RE: GEAUGA COUNTY
THOMPSON TWP
INDUSTRIAL STORM WATER
RW SIDLEY THOMPSON PLANT

On November 15, 2012, and November 28, 2012, I performed a compliance inspection of storm water best management practices at the above referenced facility located at 6900 Madison Road. You met with and accompanied me and Laura Weber of the Division of Surface Water (DSW) during our inspection. Our records indicate storm water discharges from this facility are authorized under the Ohio EPA General National Pollutant Discharge Elimination System (NPDES) Permit for Storm Water Associated with Industrial Activities #3GR01736*EG.

Fig 1. Concrete Burial Yard. Storm water runoff flows toward the tree line.

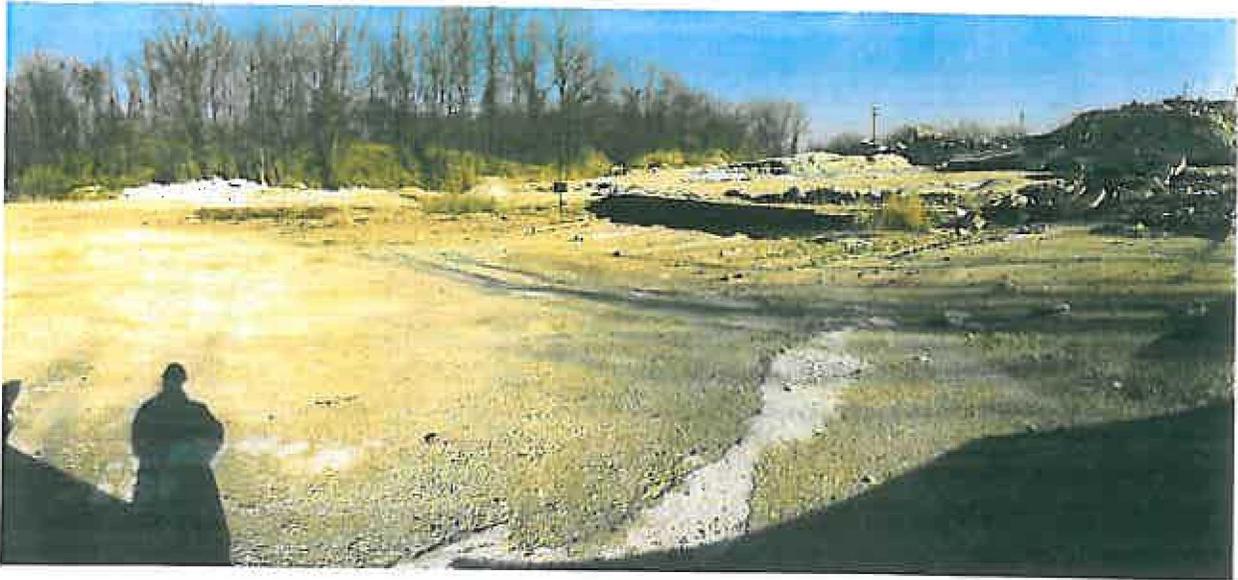
- We observed evidence of pollutants discharging from the Concrete Burial Yard. Excess batches of concrete are brought to this area to harden and then recycled through the concrete crusher. However, before the batch hardens, washwater or seepage from the concrete drains into an unnamed tributary of Mill Creek. We observed colorants and particulates associated with concrete flowing from the Concrete Burial Yard into the stream. Measures such as berming or placing batches within excavated pits can be implemented to prevent these discharges. This outfall is one of the unidentified outfalls from the facility.

Fig 2 & 3. The Concrete Burial Yard discharges into this swale and then down a slope to the east. This outfall of storm water is not identified in the SWPPP and must be added to the plan and sampled for quarterly visual and benchmark monitoring. Note colorant discharge in photo on left.

Fig 4 (LEFT). The Pro Angle Wet Plant pond was discharging on the date of inspection. Storm water and process water are co-mingled in this pond.

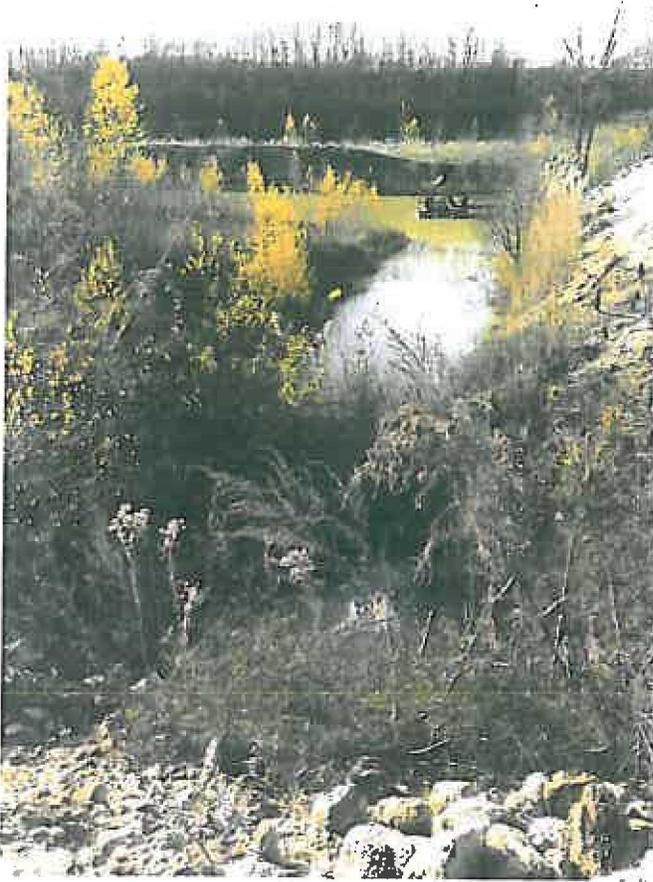
We noted that this facility generates process wastewater which collects within the Concrete Batch Plant Pond, Sand Wash Plant Pond and Pro Angle Wet Plant Pond. Please be aware that your existing NPDES permit does not authorize the discharge of process wastewater. As such, RW Sidley must take measures to ensure that no process wastewater is discharged from the facility or seek additional NPDES permit coverage for these discharges. Our observation of the Sand Wash Plant Pond indicated that there may be occasional discharges due to overflow in the NE corner of the pond. Erosion rills were observed from the pond down the slope above Ledge Road. Measures such as raising the berm or increasing recycling of washwater back to the wash plant are steps that can be taken to prevent future discharges. In addition, the Pro Angle Wet Plant Pond was discharging when we observed it on November 15, 2012. You indicated that this water is to be recycled back to the Pro Angle Wet Plant. Again, increasing recycling or the holding capacity of the pond may prevent future unauthorized discharges of process water.

Fig 5 (RIGHT). Outfall 001. The Pro Angle Wet Plant pond is tributary to this outfall. Note the discharge despite no rainfall.
